**CITY OF MERCER ISLAND  
DESIGN COMMISSION  
STUDY SESSION STAFF REPORT  
EXTERIOR REMODEL**

**Agenda Item: 1  
December 12, 2018**

Project:	McDonald's Corporation Remodel (DSR18-017)
Description:	A Design Commission study session to review an exterior remodel for an existing McDonald's restaurant in the Town Center.
Applicant:	Matt Grinnell (Freiheit Architecture)
Site Addresses:	2807 78 <sup>th</sup> Ave SE; Identified by King County Tax Parcel # 531510-1305
Zoning District:	Town Center -4 (TC-4)
Exhibits:	<ol style="list-style-type: none"><li>1. Color Elevations by Freiheit Architecture, dated received on November 8, 2018</li><li>2. Site Plan, Demo, and Elevation drawings, dated received on November 8, 2018</li><li>3. Examples of Post Construction, dated received on November 8, 2018</li><li>4. Applicant Questions, dated received on November 8, 2018</li></ol>

TITLE: 2018 MRP REMODEL  
 CORE 16  
 SHEET NO. A2.0  
 ELEVATIONS

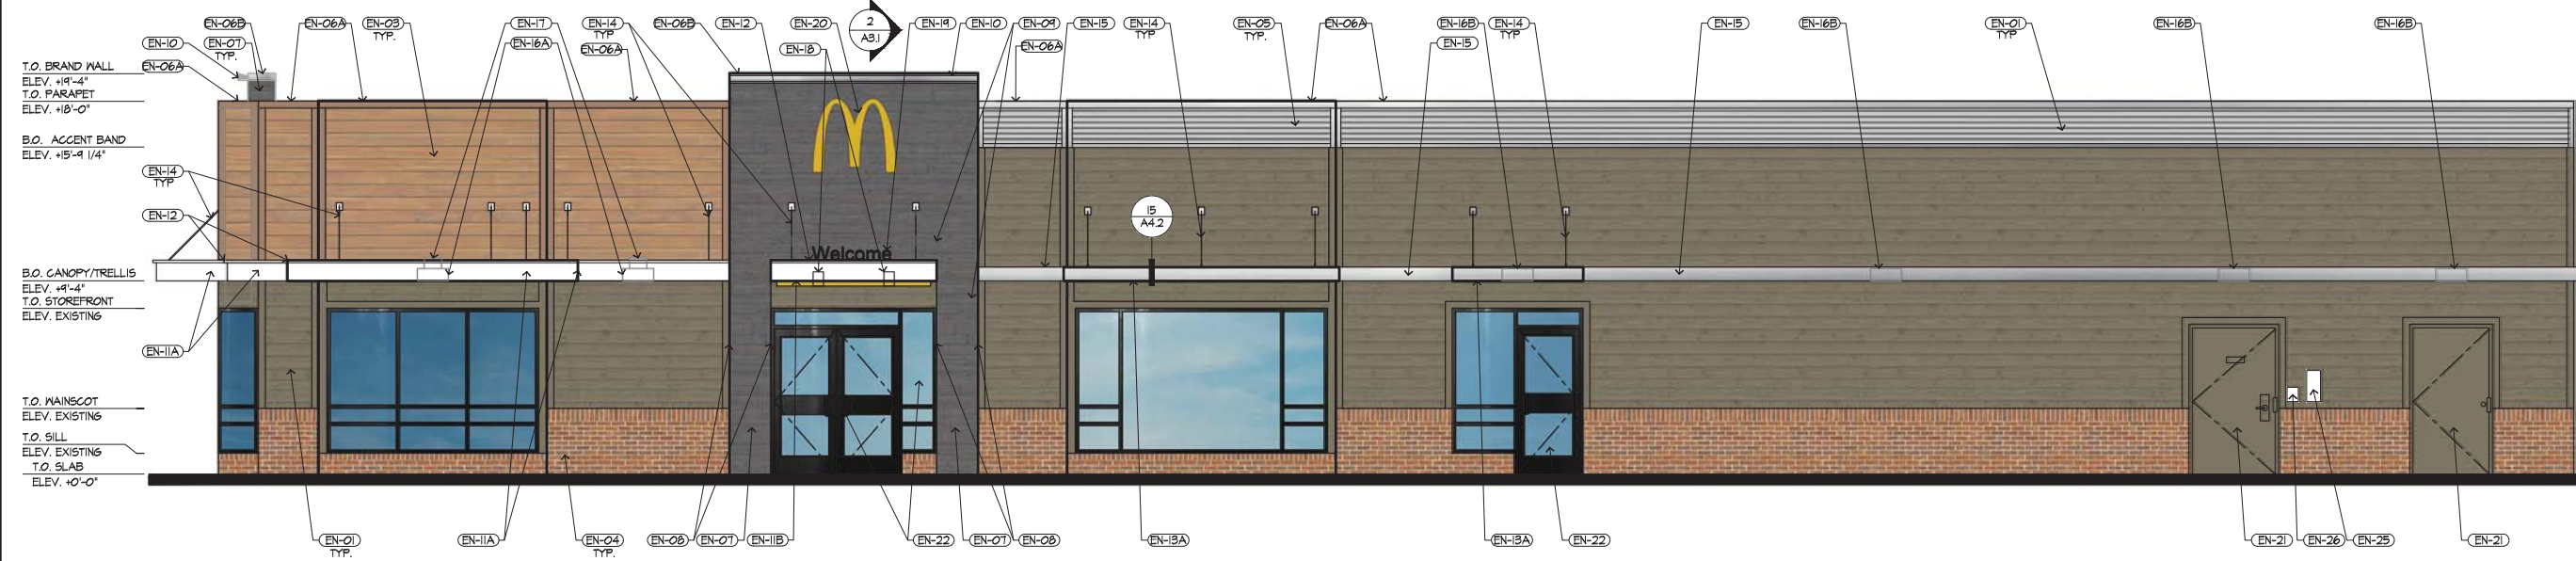
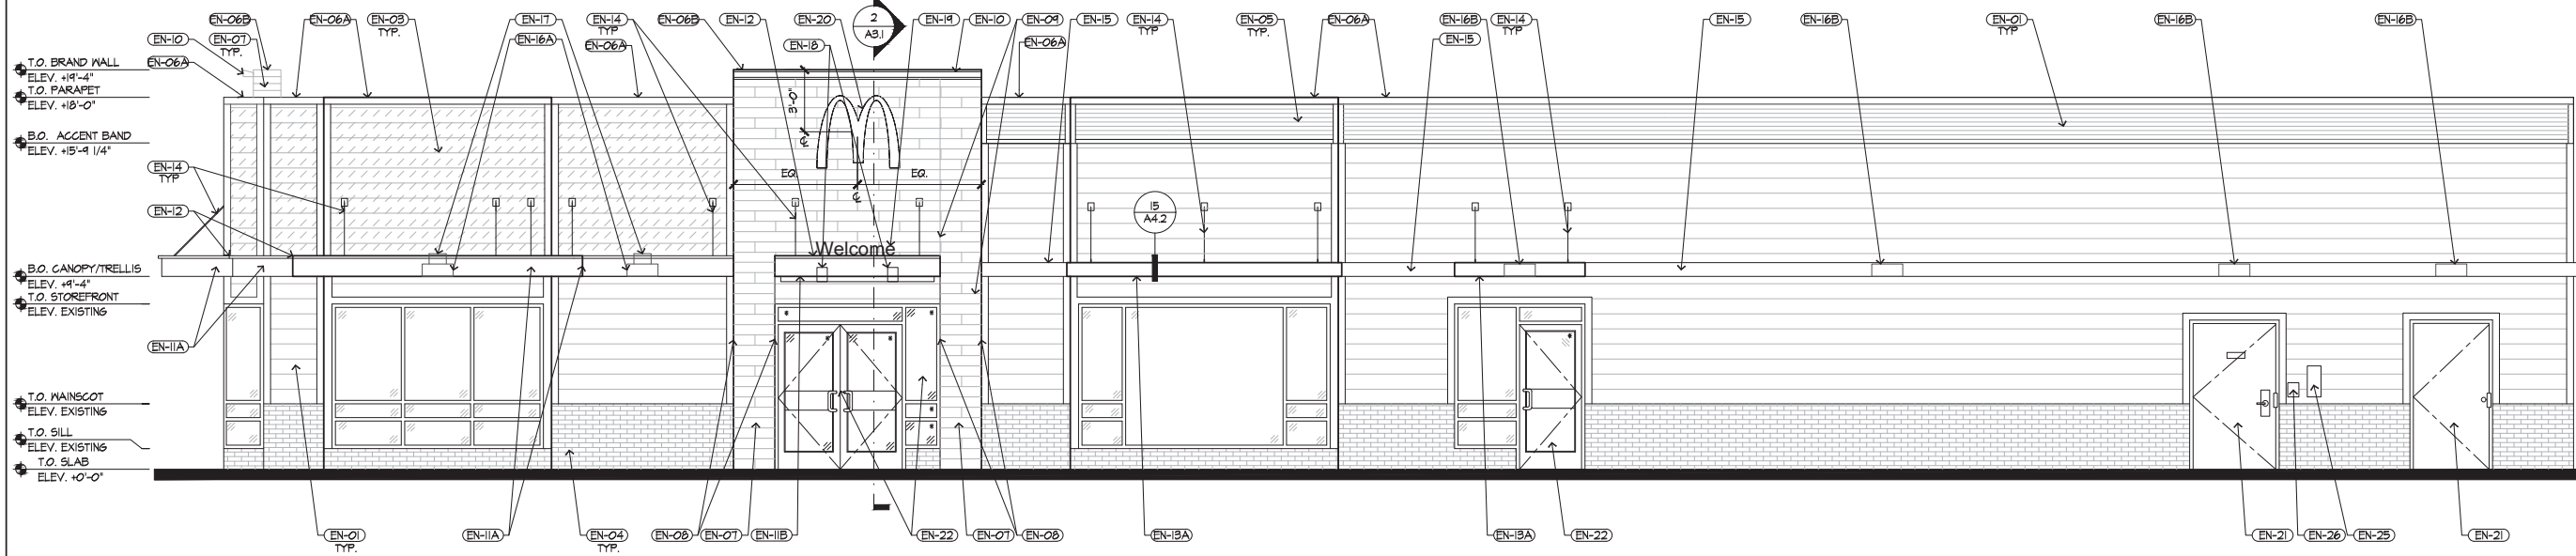
As shown on Exhibit 1, the cement lap siding, tile, and brick meet appear to meet the standards. Clarification is needed in regards to the aluminum trellis, metal fascia, and corrugated metal parapet meet the standards. Standard #7 above does states that beveled metal siding is an undesired material and should be limited to use as a minor building element. Does this apply to all metal materials? If so, the trellis, fascia, and parapet are minor building façade elements and may be composed of metal materials. Does the design commission agree?

A wall sign is allowed on the west elevation because it faces a street. The south elevation does not face a street, so a wall sign is not allowed on that elevation. (Exhibit 1)

Awnings that contain graphics used as signage are considered to be projecting signs pursuant to MICC 19.11.140(B)(3)(d). This code section insinuates that projecting signs come in forms other than blade or marquee signs. Are signs attached to canopies also projecting signs? If so, is the proposed “welcome” sign attached to the canopy above the main entrance to the building on the south elevation (Exhibit 1) a projecting sign?
